# Access Compliance Report

## Public Rights-of-Way

### (Curb Ramps)

Intersection ID: 23481	Main Street: ALEXANDER_RD	Cross Street: PROVIDENCE_RD	Location: SE
ADA ID: 4B40C19BEB34	Ramp Type: Perp	Initial Pass/Fail: Fail	Overall Compliance: No
Severity Score: 22.5			
Codes/Mitigation Info/Possible Solution		Field Measurements/Component Compliance

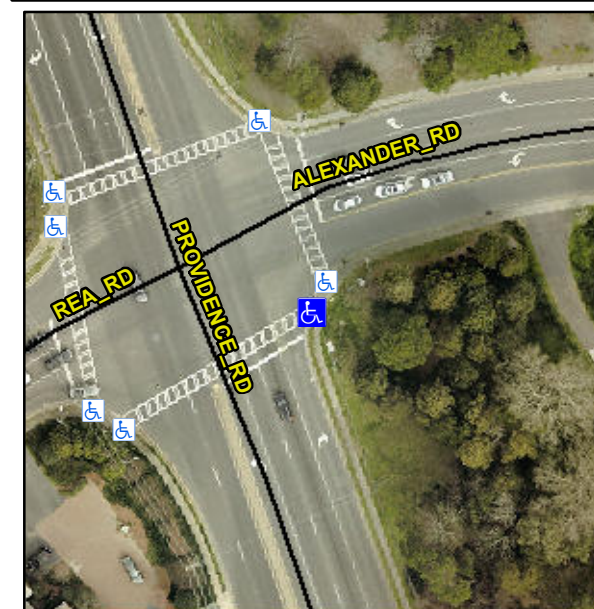
**Remove & Replace Entire Ramp.**

**R304.5.1, R304.2.2, R304.5.3**

Compliance	Description	Data	Compliance	Description	Data
N/A	Ramp Length (in)	72.0	No	Ramp Slope (%)	8.7
No	Ramp Width (in)	45.0	No	Ramp XSlope (%)	3.7
N/A	Flare Type LT	N/A	N/A	Flare Type RT	N/A
N/A	Flare Slope LT (%)	N/A	N/A	Flare Slope RT (%)	N/A
N/A	Flare Traversable LT?	N/A	N/A	Flare Traversable RT?	N/A
N/A	Landing Length (in)	N/A	N/A	DWS Provided?	N/A
N/A	Landing Width (in)	N/A	N/A	DWS Contrast?	N/A
N/A	Landing Slope (%)	N/A	N/A	DWS Length (in)	N/A
N/A	Landing X Slope (%)	N/A	N/A	DWS Full Width?	N/A
N/A	Landing Curb? (Y/N)	N/A	N/A	DWS Offset (in)	N/A
N/A	Shared Landing?	N/A			
N/A	Gutter Ponding?	N/A	N/A	Gutter Slope (%)	N/A
N/A	Gutter Lip Ht (in)	N/A	N/A	Gutter X Slope (%)	N/A
N/A	Painted X Walk1?	Yes	N/A	Painted X Walk2?	N/A
	X Walk 1 Direction	To SW		X Walk 2 Direction	N/A
N/A	X Walk 1 Width (in)	72.0	N/A	X Walk 2 Width (in)	N/A
	X Walk 1 Slope (%)	0.3		X Walk 2 Slope (%)	N/A
	X Walk 1 X Slope (%)	3.3		X Walk 2 X Slope (%)	N/A
